UNITED STATES ENVIRONMENTAL PROTECTION AGENCY

Re: Lower Passaic River Study Area (LPRSA) Draft Remedial Investigation Report –
Administrative Settlement Agreement and Order on Consent for Remedial
Investigation/Feasibility Study (Agreement) CERCLA Docket No. 02-2007-2009

Lower Passaic River Study Area Remedial Investigation Report Response to Comments for Section 7 and Modeling Appendices

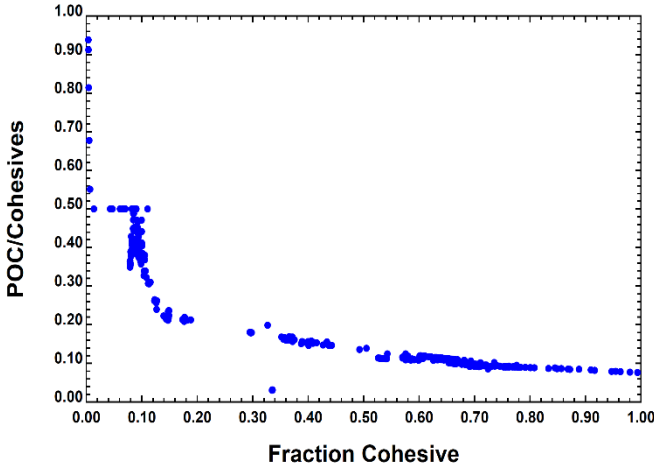
527	Appendix N	Specific	Section 3.2, page 9, first sentence	Please remove the reference to grid cell 323, as the reference is unclear and the RM and grid indices are sufficient to identify the location. Results for additional locations should also be presented with the CPG’s OC model compared to data.	The requested change will be made.	Response accepted, pending review of the revised figures and associated description in the text. Categories: RI Document Sub-Categories: Figures, Text Clarifications

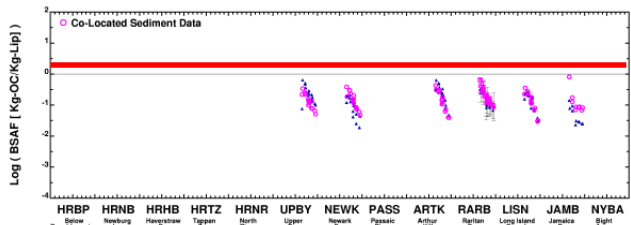
565	Appendix O	Specific	Attachment 1, Figures 3 through 22	<p>Please adjust the figure scales so that lower contaminant concentrations can be distinguished from zeroed areas. Please include additional breaks that distinguish zero separately, and add greater resolution at the low end of the scale. The scale should include breaks for relevant human health and ecological risk screening values and the estimated background concentration.</p>	<p>A break for zeroed values and one additional break in the lowest bin will be added to the maps in response to the request (e.g., 100 ng/kg 2,3,7,8-TCDD). Additional breaks will not be added to the color scale, so as to maintain a clear presentation in which colors are easily differentiated.</p>	<p>The requested changes to the color scale must be made to distinguish between areas that presently fall below or exceed relevant concentration thresholds. If necessary resolution at the high end of the scale can be sacrificed.</p>

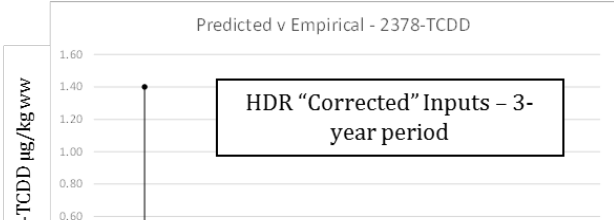
587	Appendix P	Specific	Section 3.3.4, page 52, second paragraph and Table 3-12	Please explain why whole-body samples for bullhead (n=6), shad (n=3), small forage fish (n=4), mummichog (n=18), perch (n=22), and benthic invertebrates (n=19) were omitted from the weight-of-evidence calibration approach. These species must be included within the calibration approach.	See Response to Comment 409.	See EPA response to comment 409: “Even though some of these organisms have lower sample sizes, this line of evidence should not be removed from the model calibration assessment.”

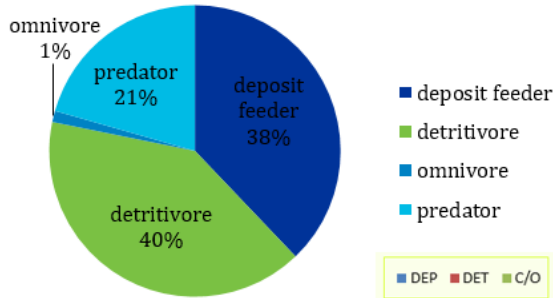
No.	Section	General or Specific	Page No.	EPA Comment – 4/14/16	CPG Response – 2/9/17	EPA Evaluation of Response – 5/9/17
610	Appendix P, Appendix B	Specific	Appendix B, Section 2.3.4, page 10, Equations 20 and 21	More information about the basis for the model’s growth-rate allometrics is required. The Arnot and Gobas (2004) paper and the citations it references in support of its allometric estimations do not clarify whether these estimations are based on fish, invertebrate, or mixed data, nor the range of weights to which these estimations should apply. Allometric equations can be in error when they are applied at the edge of their domain or when extrapolating below measured organism weights. For benthic invertebrates, given the poor performance of the model discussed in Comment No. 595 , the absence of site-specific organism weights, and uncertainty as to whether this allometric formulation was derived using invertebrate data, species-specific growth rates should be used in place of the Arnot and Gobas (2004) estimations.	A literature review will be done to determine the most appropriate grown-rate allometrics. These will be updated as needed.	<p>The response is accepted pending review and approval of the model revisions and revised text. EPA notes that any modeling code, inputs, results, and interpretation of results will be subject to EPA review.</p> <p>Categories: Bioaccumulation Model Sub-Categories: Inputs, Growth Rates</p>
